STAFF REPORT: 11/12/2025 MEETING

ADDRESS: 1427 EDISON

APPLICATION NO: HDC2025-0065

SCOPE: DEMOLISH GARAGE, ERECT GARAGE

Photo taken by HDAB in 1974, at time of the district's designation. Note aluminum siding in main roof and porch gable ends.

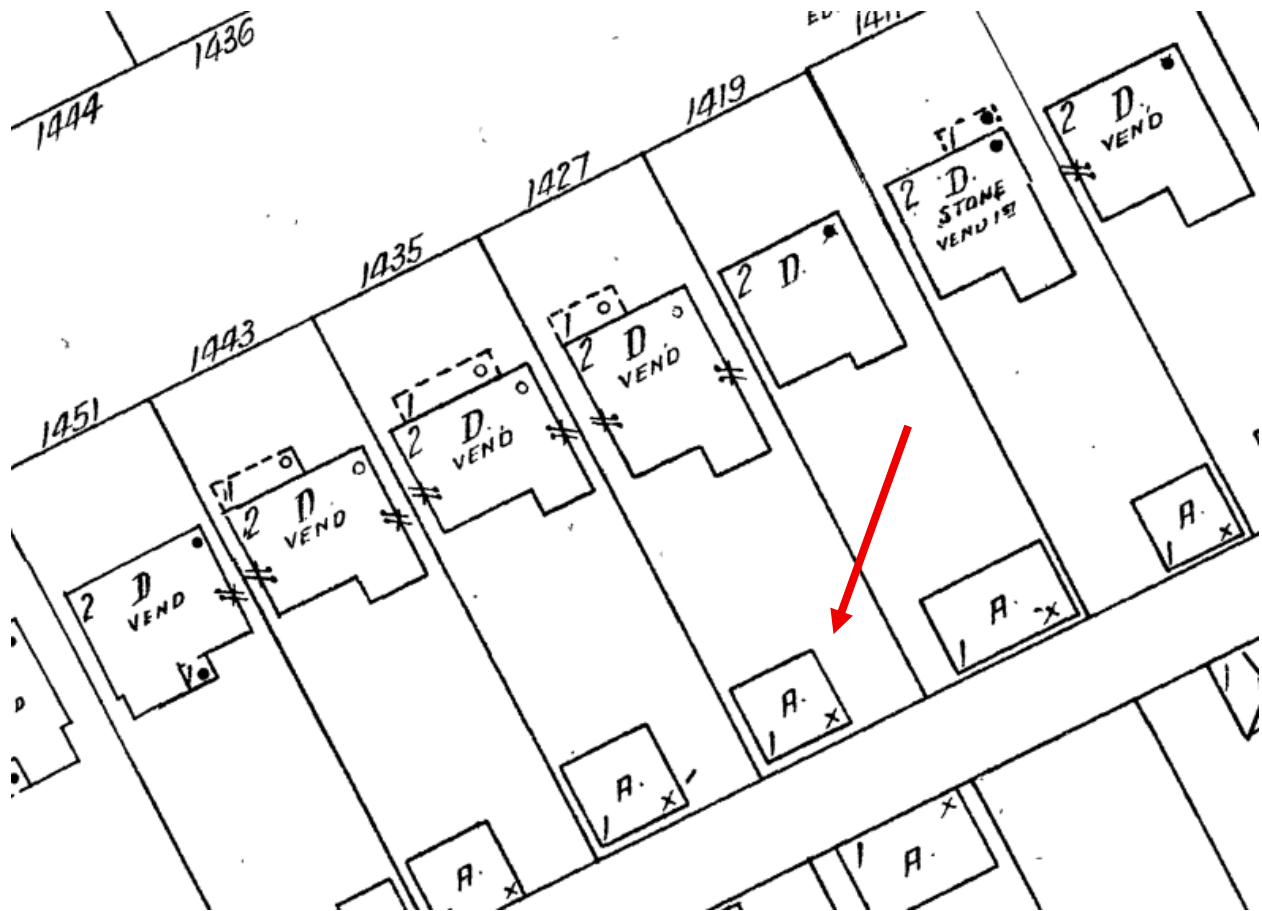
- The Boston Edison Historic District was designated in 1974
- Per the above designation slide, taken in 1974 by the HDAB, the current aluminum siding located in the building's gable ends was present at the time of the district's designation

Sanborn Fire Insurance Map, 1969. Garage at rear yard indicated by red arrow.

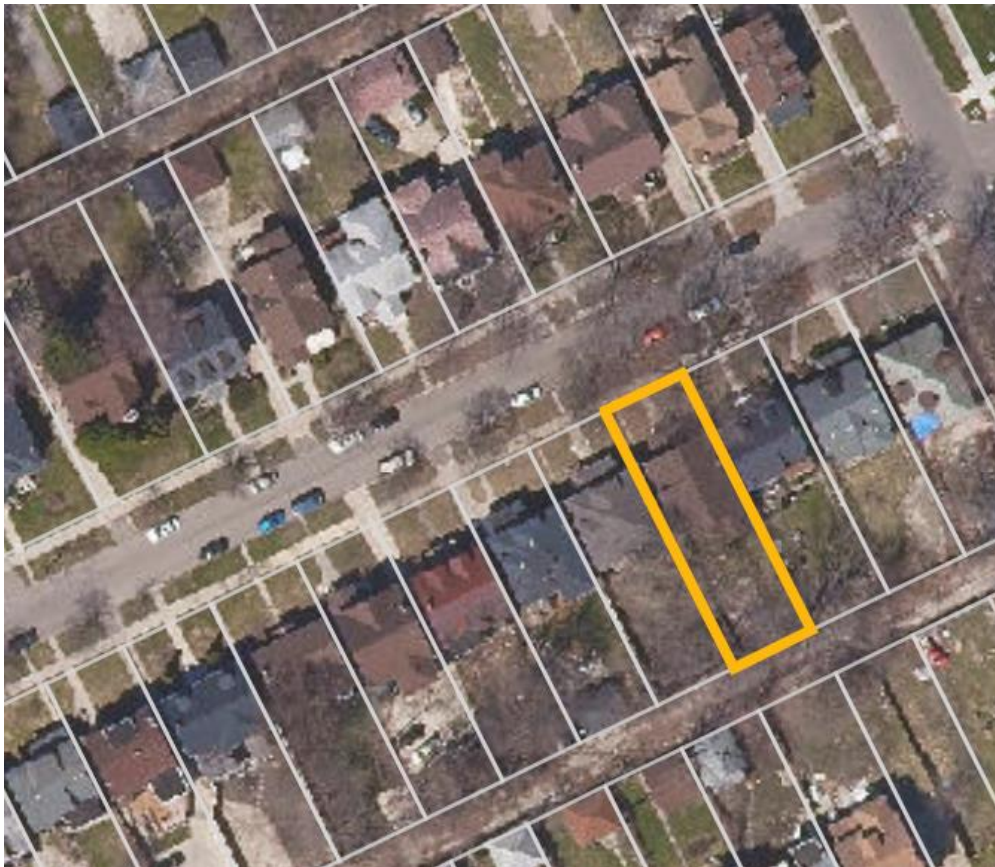
- Per the above Sanborn Map, a small garage was present at the same location as the proposed new garage/current concrete slab in 1969. A review of birds eye images of the property (see below) indicates that this garage was demolished sometime between 2006 and 2011. Staff notes that the HDC does not have a COA on file for the garage's demolition. Staff therefore reached out to the applicant to note that the current application would be considered incomplete unless the demolition of the garage was added to the current scope. This was required because a new garage cannot be built at the location of the old garage without a legal/HDC-approved removal of the previous structure. The applicant is therefore seeking the Commission's "after-the-fact" approval for the removal of the property's garage. Staff acknowledges that the current owners purchased the property in 2025/the unapproved garage demolition was completed by a previous owner. However, note that existing violations remain with the property until legally addressed.

1427 Edison outlined in blue. Bird's eye view, 2006. Note that the garage is present to the rear of the house

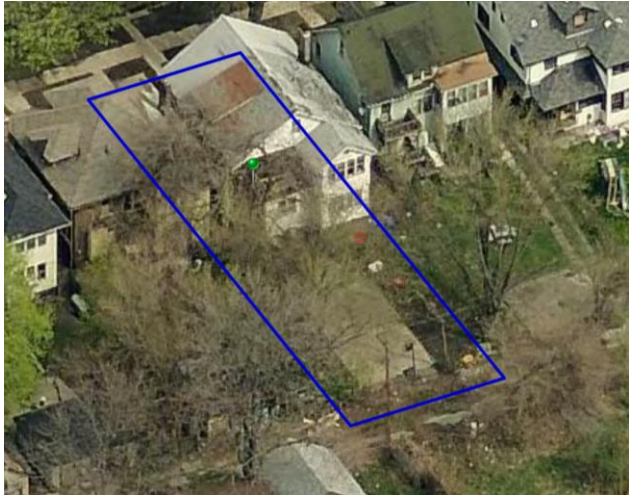
- Staff has no photographic documentation of the garage prior its demolition beyond the above Sanborn Map and bird's eye view images. As such, staff cannot opine on the garage's condition at the time of its demolition, nor can staff recommend that the resource contributed to the historic district. Furthermore, the contributing status of the garage is not provided in the district's National Register of Historic Places listing and a report for the local historic district was not completed by the Detroit Historic Designation Advisory Board upon its designation.
